Process Presentation
Lighting
Iron - Furniture - Sculpture
Legrand – Lumicor – LED

CONSULTING
DESIGN & MANUFACTURING
ADG Lighting
Architectural Detail Group, Inc

PROPOSED
EXTERIOR ELEVATIONS

PROPOSED FLOOR PLAN

Basket ball court light well

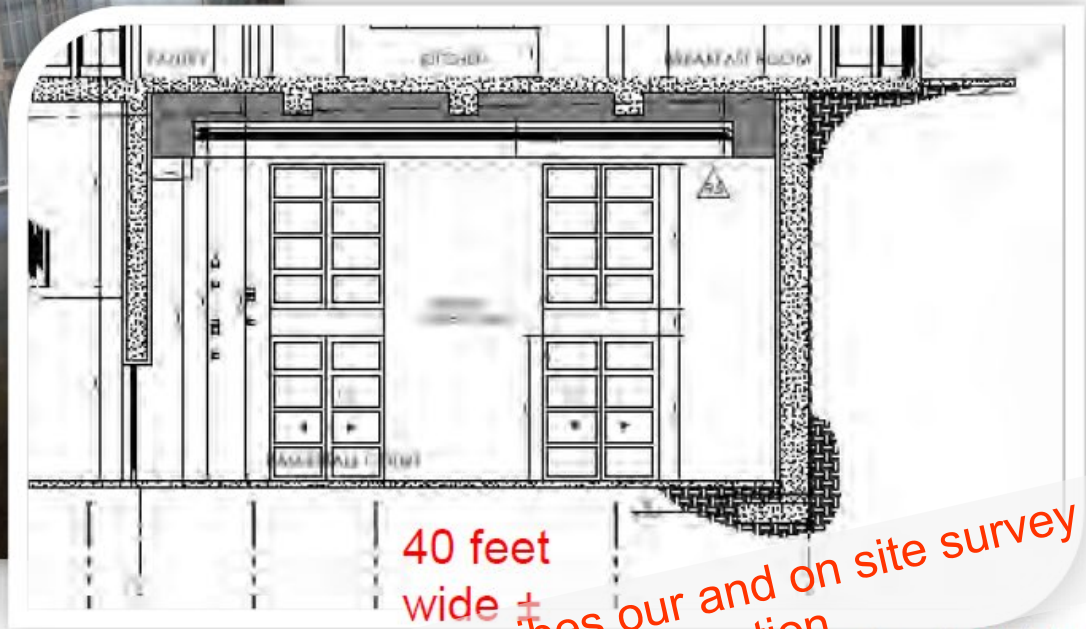
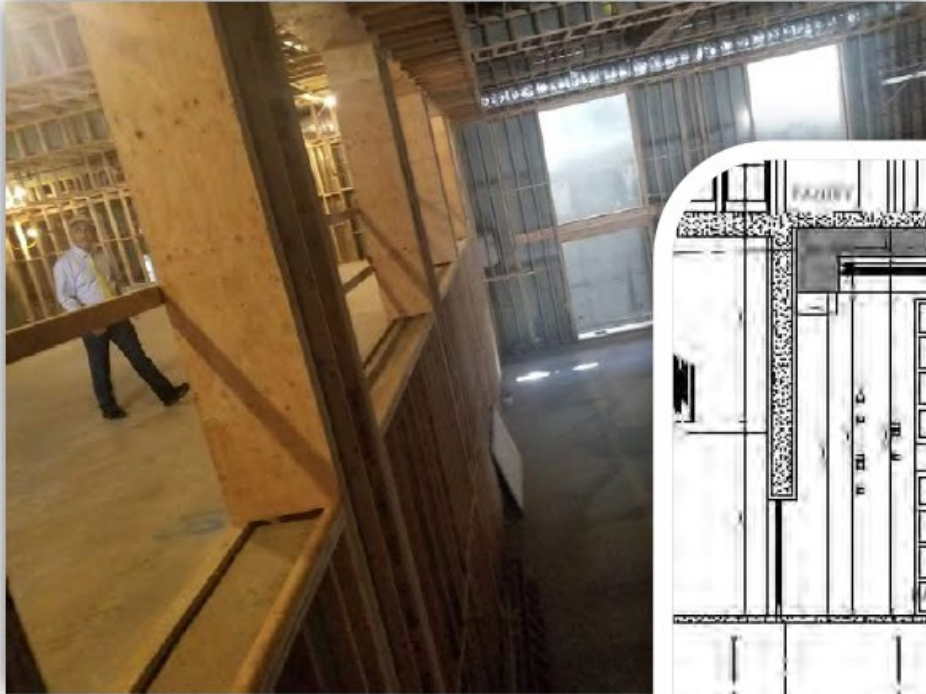
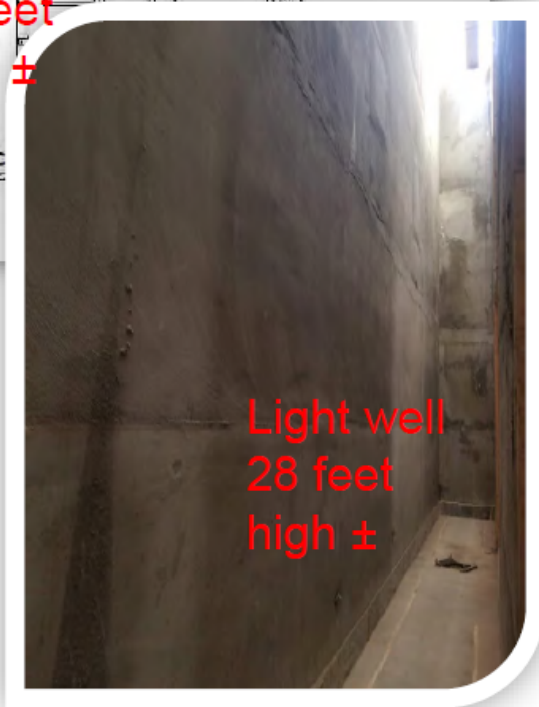
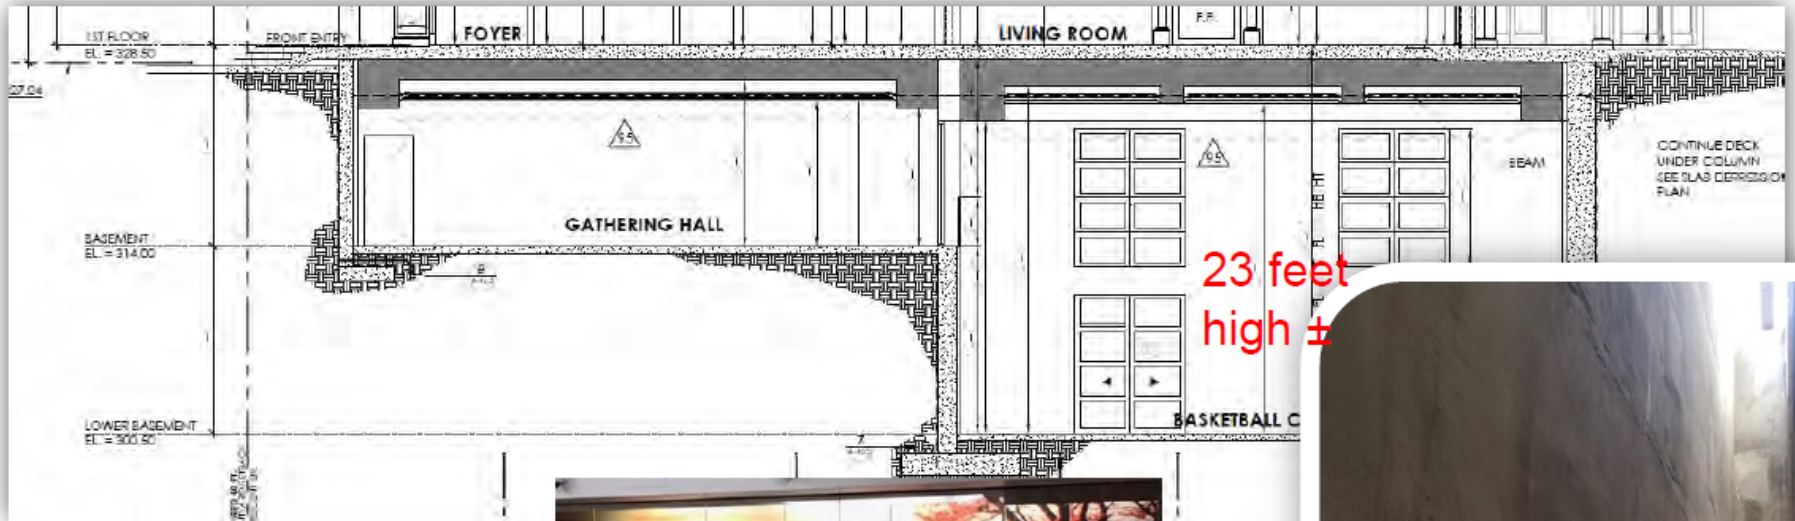
40 feet
wide ±

23 feet high ±

Light well 28 feet high ±

Ideal is to use a nature scene with DXF controlled color to simulate nightscape and sunrise lighting

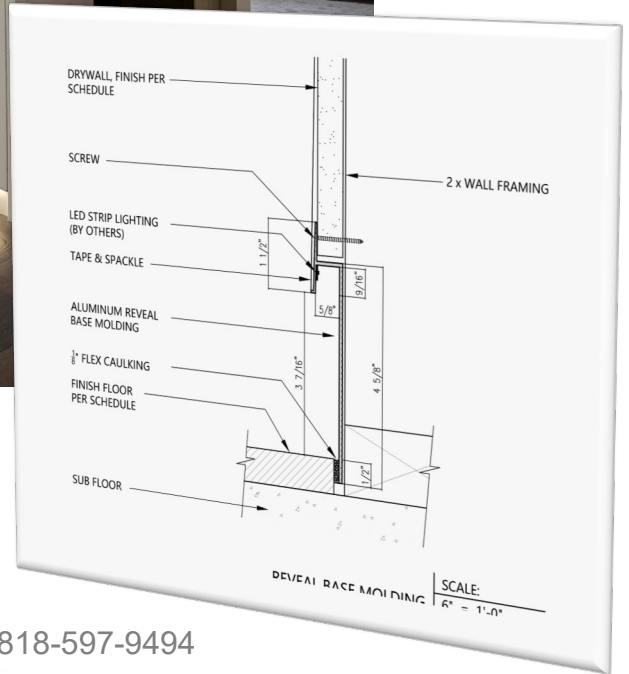
Crush glass light up as alternatives

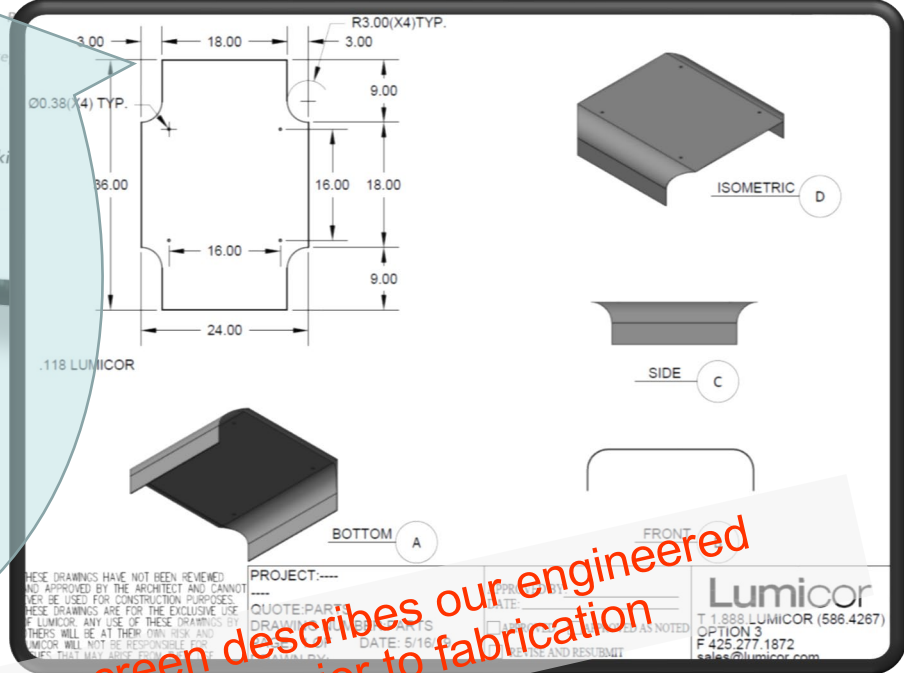
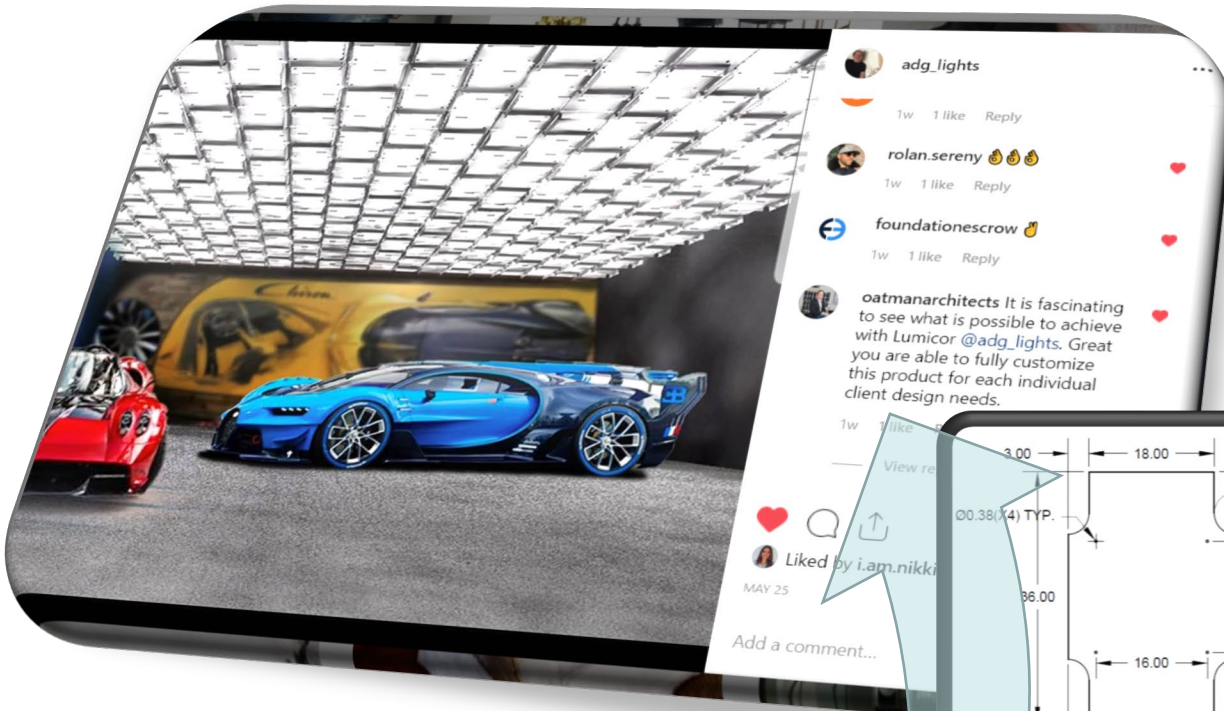
Issue is illumination spotting & glare
Solution is complete reduction
